Docket No. 50-282

Change No. 2
 License No. DPR-42

CHANGES TO APPENDIX B
ENVIRONMENTAL TECHNICAL SPECIFICATIONS FOR LICENSE
NO. DRP-42

APPENDIX B
TO
OPERATING LICENSE DPR-42
ENVIRONMENTAL
TECHNICAL SPECIFICATIONS AND BASES
FOR
PRAIRIE ISLAND NUCLEAR GENERATING PLANT
UNITS 1 AND 2
NORTHERN STATES POWER COMPANY
DOCKET NOS. 50-282 AND 50-306

FIG. 4.1.1-2
A

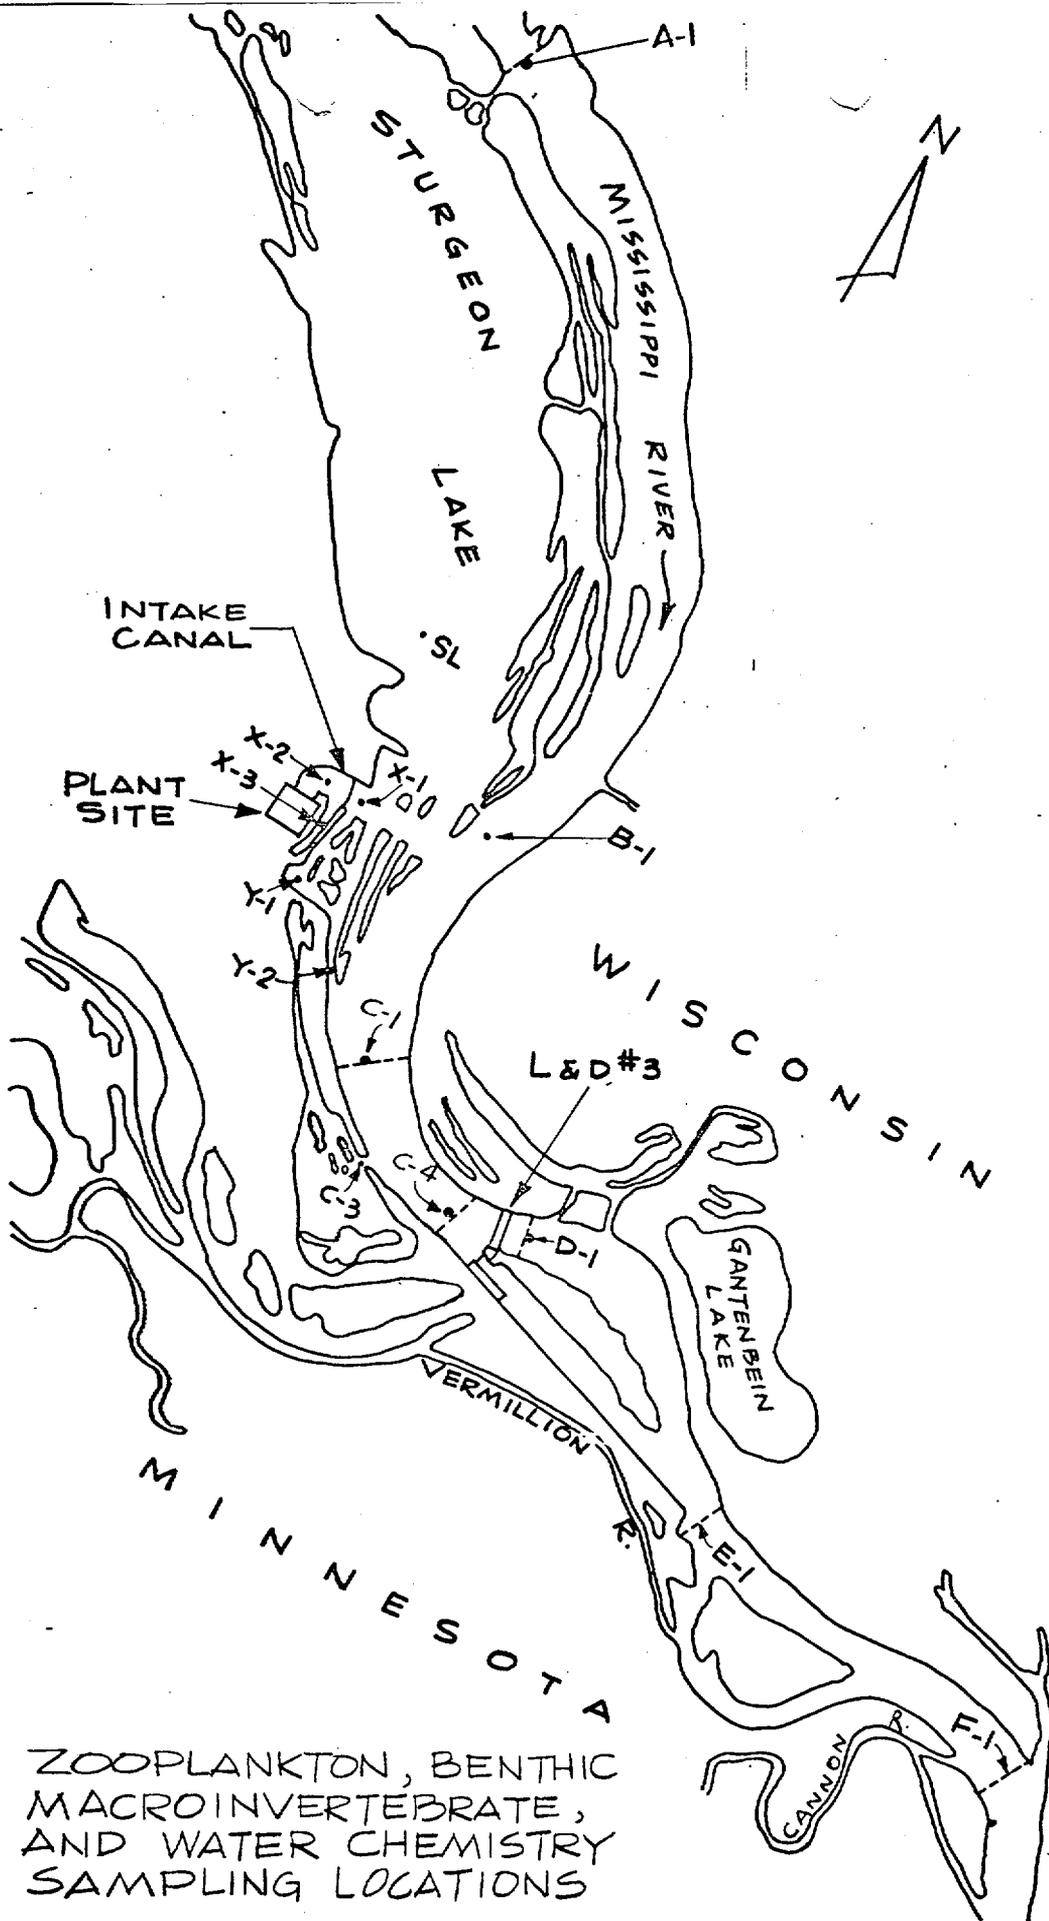
B-18	4.1.1 B		specification reworded for clarification
B-20	4.1.2		basis reworded for clarification
B-22	4.2.3		specification updated
	4.2.3		last sentence of basis deleted because of redundancy
	4.2.4		last sentence of basis deleted because of redundancy
B-23	4.2.5		last sentence of specification deleted because of redundancy
B-24	5.1.2	C	deleted because of redundancy
	5.1.2	D	changed to C and rewritten to include the delineation responsibility for the audit function
	5.2		updated
B-25	5.3.1		updated
	5.3.2		updated
B-26	5.4.1	B	updated
	5.4.2	A	updated
	5.4.2	B	deleted for consistency
	5.4.2	C	deleted for consistency
	5.4.2	D	changed to B
	5.4.2	B.1	added sentence to require evaluation of environmental impact of any changes
	5.4.2	B.3	updated
B-30	figure 4.1.1-2		updated by adding three new locations.

Sampling locations are shown in Figure 4.1.1-2. The samples are analyzed every two weeks. Data on chlorophyll content and abundance are determined from the samples. Ice conditions may restrict sampling during the winter months.
